**Your ref: 3/2023/0118; 8 Hammond Drive, Read BB12 7RE**

Further to your letter dated 22 February 2023, we write to object to the retrospective planning application number 3/2023/0118 and invite the Council to require the development to be constructed in accordance with the approved applications 3/2021/0428 and 3/2021/1074. We would not have agreed to the original applications had the property been constructed in the way that is now being proposed.

**(1) Building error to the eastern boundary**

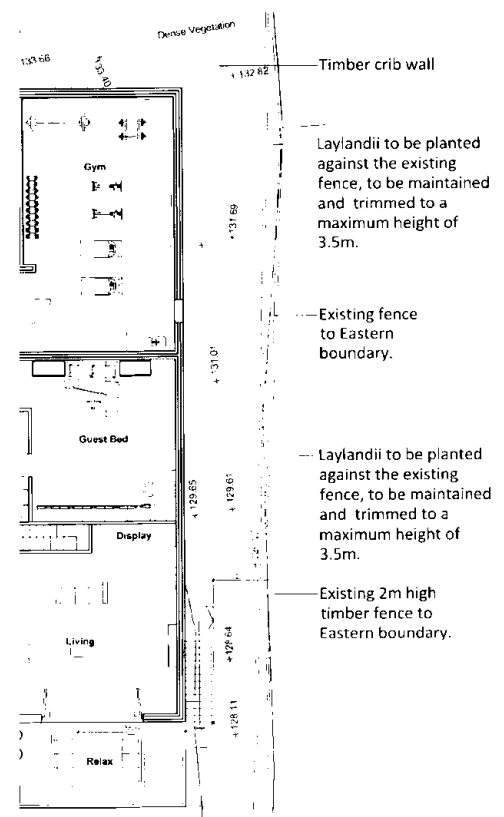
Contrary to the approved applications, the entire wall to the eastern side of the development has been constructed too close to the fence. The approved (and even the proposed) site plans require there to be a distance of 2-metres between the fence and the eastern side of the stairway (which has not to be constructed):

It is important to emphasise that the 2-metres is not to the eastern wall; it is to the east side of the stairway. This stairway has yet to be added to the eastern wall which will further impact on its proximity to the fence. The width of the stairway is not detailed on either plan but, according to scale, appears to be approximately 1-metre. Accordingly, the total distance from the fence to the eastern wall should be in the order of 3-metres.

The distance from the fence to the stairway is 1 metre 26cm; almost 85cm less than the approved application. As a result, the entire wall on the eastern boundary is almost 85cm closer to the boundary than was approved which impacts significantly on residential amenity.

This breach of planning control increases the overbearing impact of the development, resulting in reduced outlook and light, and [REDACTED]

[REDACTED] It also means that the first and ground floor roof patios - [REDACTED] would be closer to the boundary resulting in a greater loss of privacy.

Approved application	Retrospective application

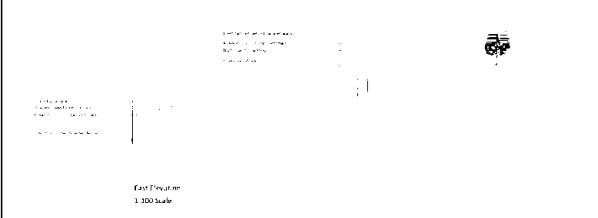
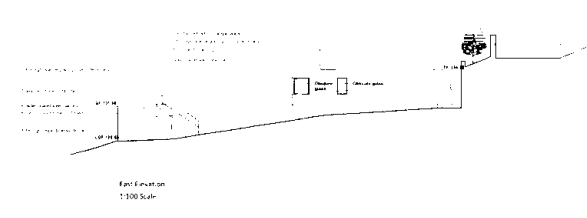
We object to the addition of a second window to the eastern wall. Given the way in which this property is being developed, [REDACTED] that it will be built according to the approved plans. [REDACTED]
